HISTORIC AND DESIGN REVIEW COMMISSION

HDRC CASE NO: 2019-628
ADDRESS: 314 W ELSMERE PLACE
LEGAL DESCRIPTION: NCB 3967 BLK 2 LOT 7&8
ZONING: R-5, H
CITY COUNCIL DIST.: 1
DISTRICT: Monte Vista Historic District
APPLICANT: Pam Carpenter/seventh generation design, inc
OWNER: CLAY AND KIM CAUTHORN/CAUTHORN KIMBERLY KLEIN & VIRGIL CLAY
TYPE OF WORK: Construction of an addition to an existing accessory structure
APPLICATION RECEIVED: October 18, 2019
60-DAY REVIEW: December 17, 2019
CASE MANAGER: Edward Hall
REQUEST:

The applicant is requesting a Certificate of Appropriateness for approval to:

**RE: 314 West Elsmere – Final Approval Resubmittal Application Written
Narrative**

SITE PLAN

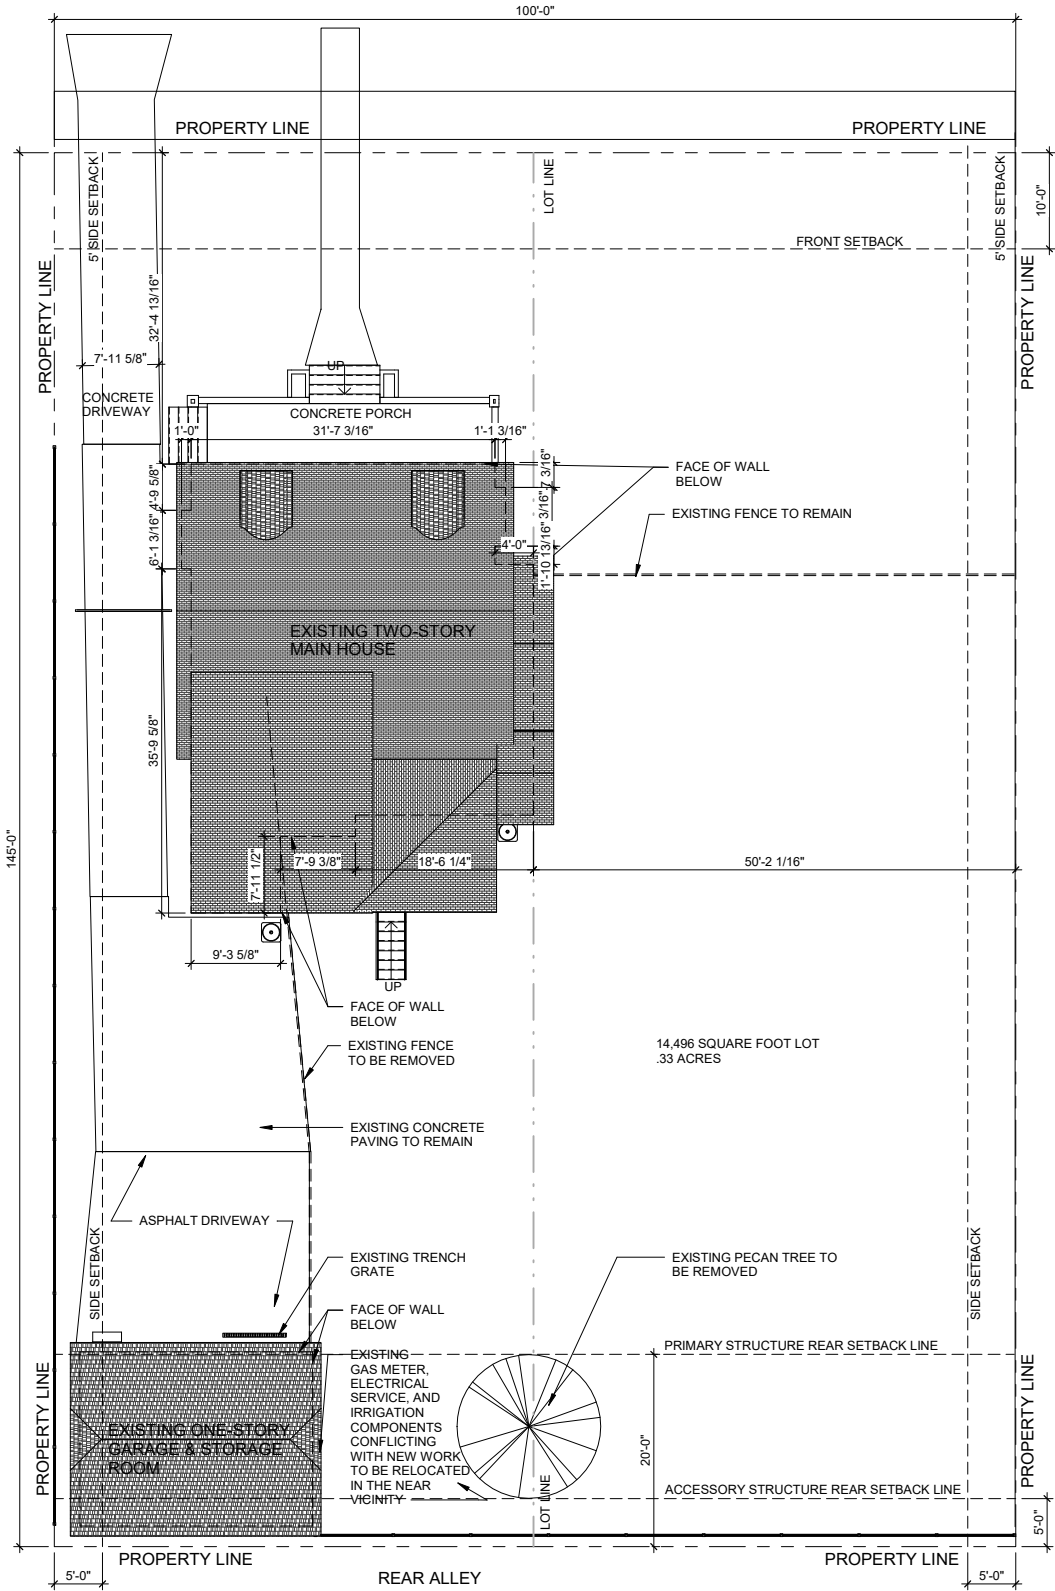
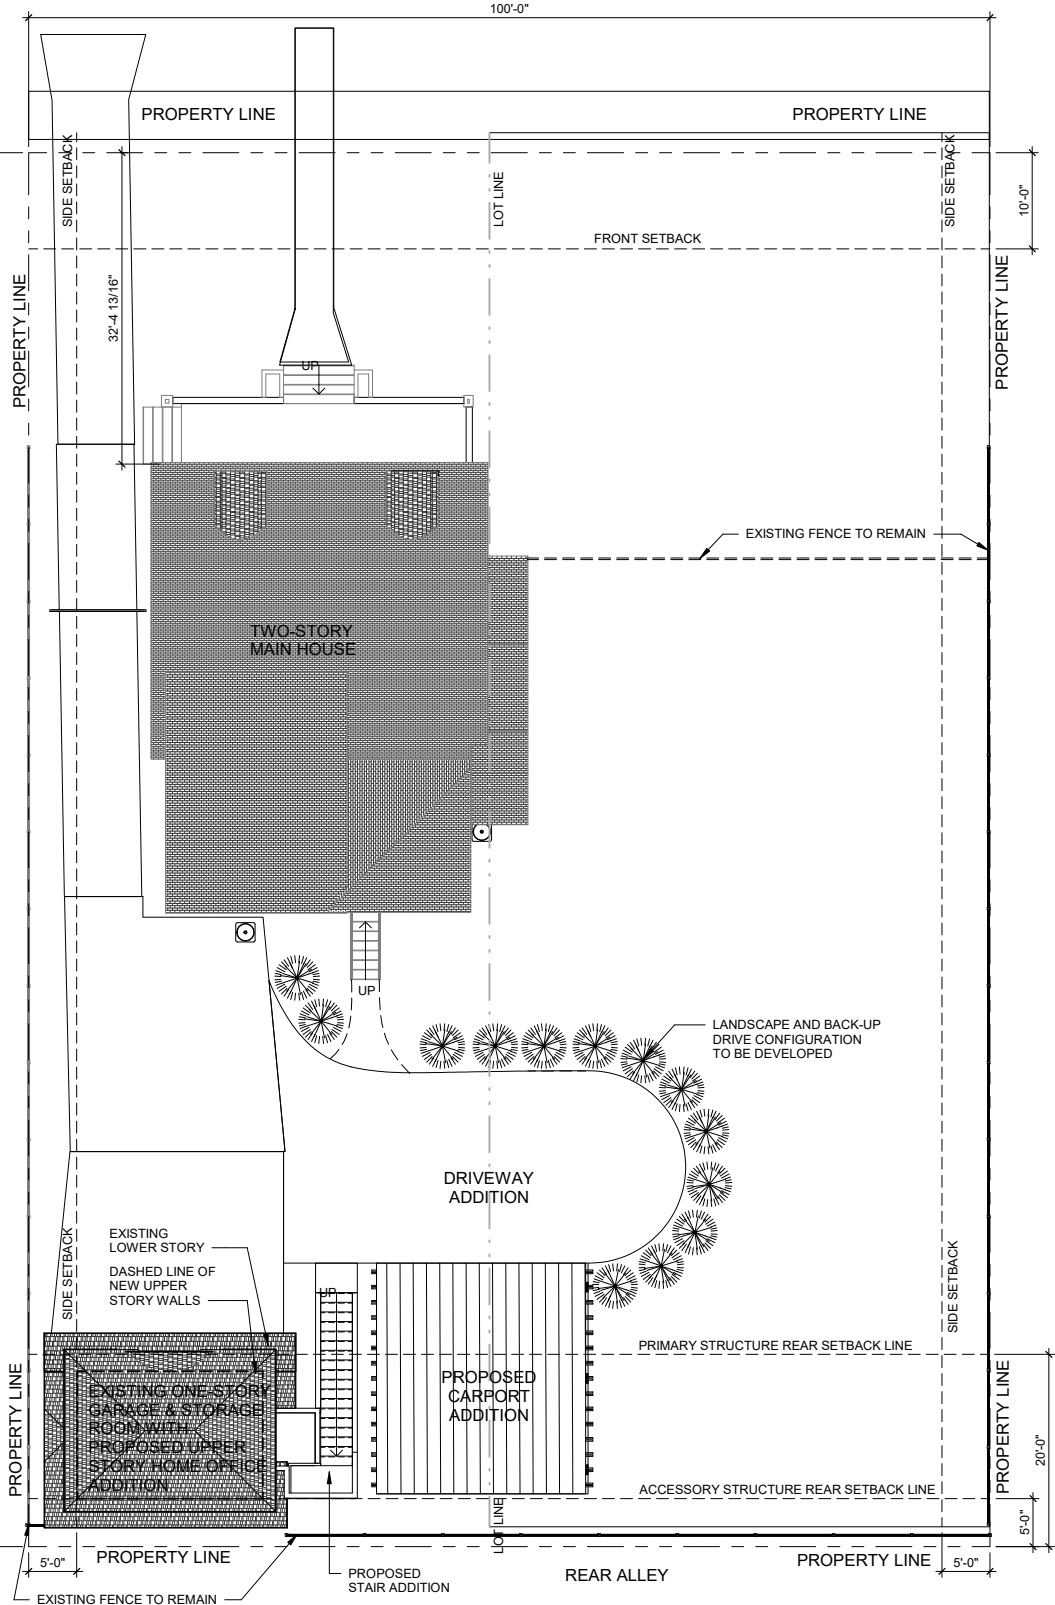
- l. **SITE WORK** – The applicant has proposed site work to include improvements to the existing driveway in the vicinity of the garage and proposed carport for vehicular maneuvering, draining and landscaping. Staff finds the proposed site work to be appropriate.

ROOF PLAN

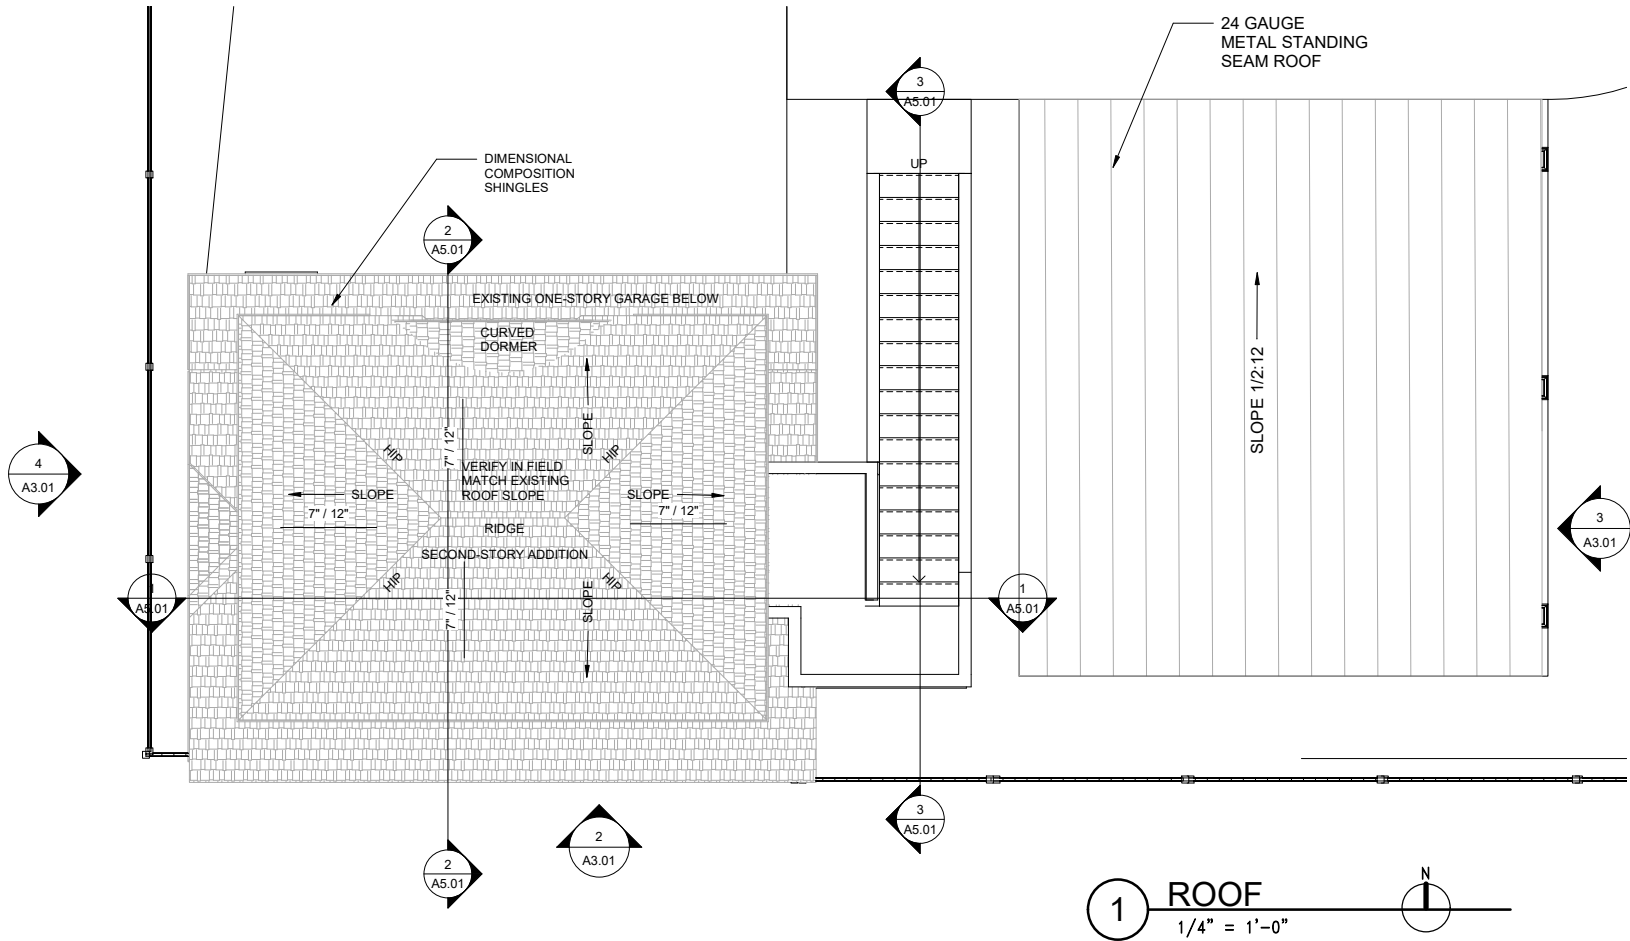
- i. That the proposed standing seam metal roof feature panels that are 18 to 21 inches wide, seams that are 1 to 2 inches in height, a crimped ridge seam and a standard galvalume finish. **The applicant has noted that this specification will be met per the application documents.**

1. CARPORT ROOFING: STANDING SEAM METAL ROOF PANELS TO BE 18 TO 21 INCHES WIDE, SEAMS ARE TO BE 1 TO 2 INCHES IN HEIGHT, A CRIMPED RIDGE SEAM IF APPLICABLE AND A STANDARD GALVALUME FINISH.

1 North Elevation
1/4" = 1'-0"

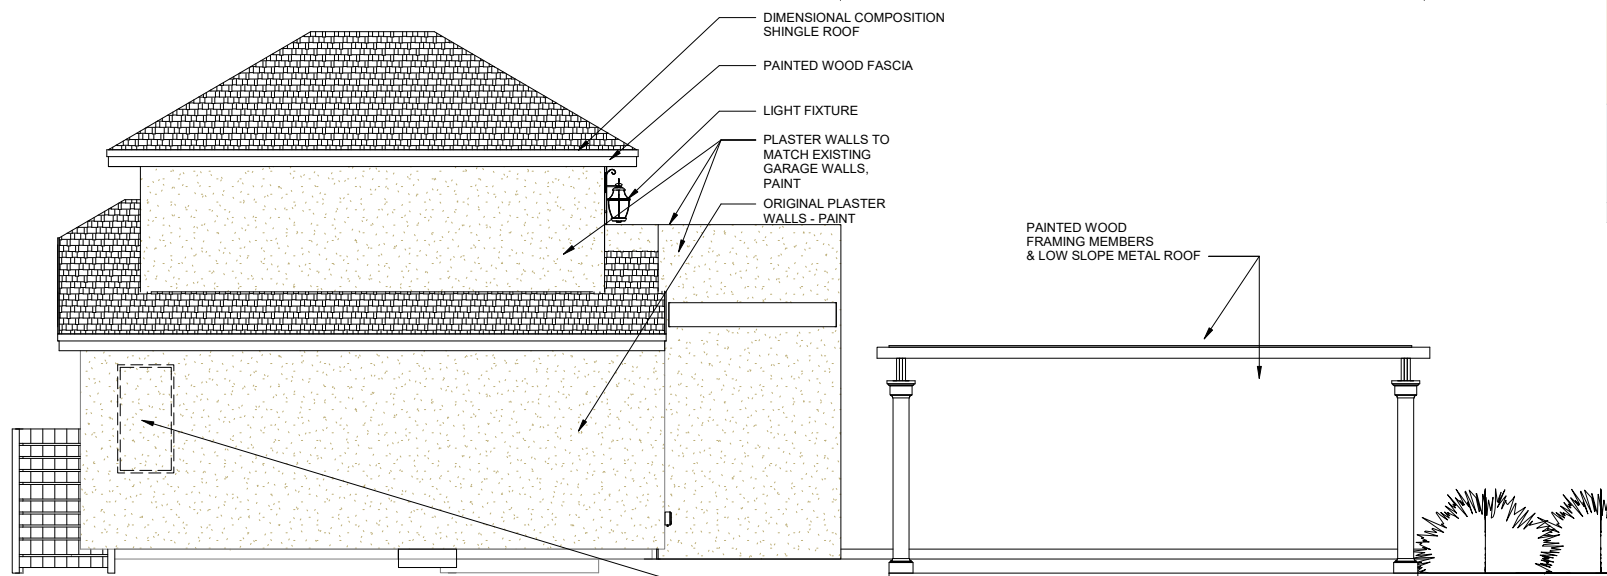
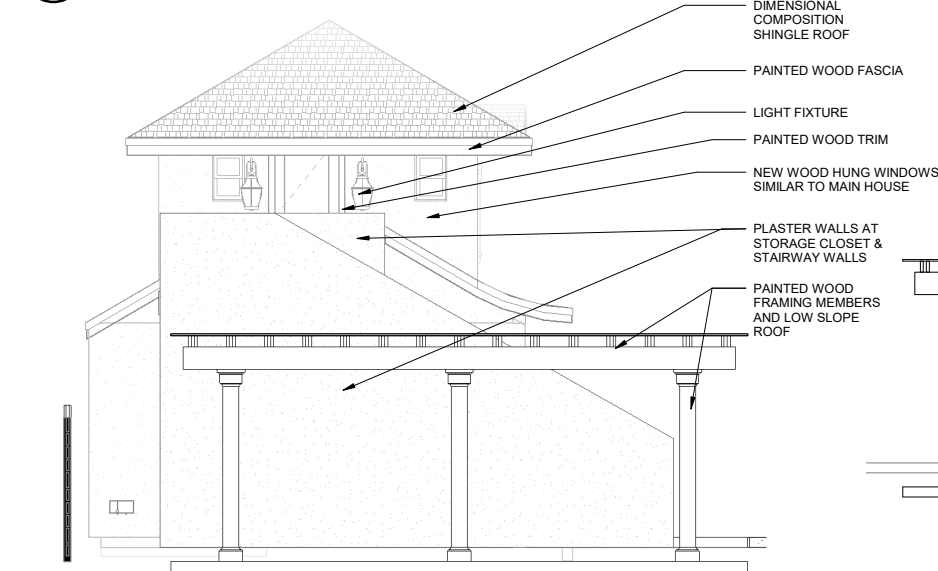
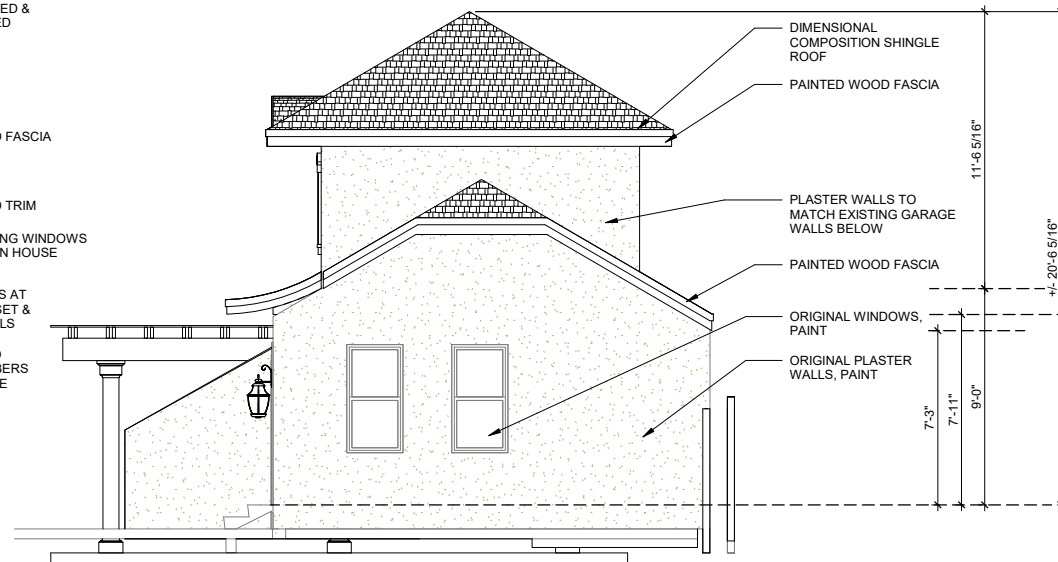
- iii. That the proposed windows feature meeting rails must be no taller than 1.25" and stiles no wider than 2.25". White manufacturer's color is not allowed, and color selection must be presented to staff. There should be a minimum of two inches in depth between the front face of the window trim and the front face of the top window sash. This must be accomplished by recessing the window sufficiently within the opening or with the installation of additional window trim to add thickness. Window trim must feature traditional dimensions and architecturally appropriate sill detail. Window track components must be painted to match the window trim or concealed by a wood window screen set within the opening. **The applicant has noted that this specification will be met per the application documents.**

- k. **WINDOW MATERIALS** – As noted in finding k, the applicant has proposed to install wood windows. Staff finds the proposed materials to be appropriate. Meeting rails must be no taller than 1.25" and stiles no wider than 2.25". White manufacturer's color is not allowed, and color selection must be presented to staff. There should be a minimum of two inches in depth between the front face of the window trim and the front face of the top window sash. This must be accomplished by recessing the window sufficiently within the opening or with the installation of additional window trim to add thickness. Window trim must feature traditional dimensions and architecturally appropriate sill detail. Window track components must be painted to match the window trim or concealed by a wood window screen set within the opening.

- WINDOWS:**
TO BE COMPATIBLE WITH HISTORIC MAIN HOUSE WINDOWS.
MEETING RAILS MUST BE NO TALLER THAN 1.25" AND STILES NO WIDER THAN 2.25".
COLOR TO BE OTHER THAN MANUFACTURER'S STANDARD WHITE COLOR.
COLOR SELECTION MUST BE PRESENTED TO CITY OFFICE OR HISTORIC PRESERVATION STAFF.
THERE SHOULD BE A MINIMUM OF TWO INCHES IN DEPTH BETWEEN THE FRONT FACE OF THE WINDOW TRIM AND THE FRONT FACE OF THE TOP WINDOW SASH. THIS MUST BE ACCOMPLISHED BY RECESSING THE WINDOW SUFFICIENTLY WITHIN THE OPENING OR WITH THE INSTALLATION OF ADDITIONAL WINDOW TRIM TO ADD THICKNESS.
WINDOW TRIM MUST FEATURE TRADITIONAL DIMENSIONS AND ARCHITECTURALLY APPROPRIATE SILL DETAIL.
WINDOW TRACK COMPONENTS MUST BE PAINTED TO MATCH THE WINDOW TRIM OR CONCEALED BY A WOOD WINDOW SCREEN SET WITHIN THE OPENING.
